UNITED STATES PATENT AND TRADEMARK OFFICE

APPLICATION NO.	FILING DATE	FIRST NAMED INVENTOR	ATTORNEY DOCKET NO.	CONFIRMATION NO.
10/531,110	04/11/2005	Stephan Bolz	9062-000167/US/USB	2622

DETAILED ACTION

Fig 2

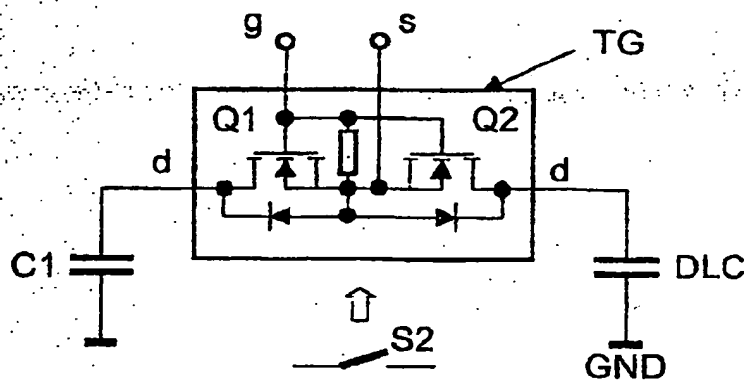
Object. Rectifier K1 is not shown.
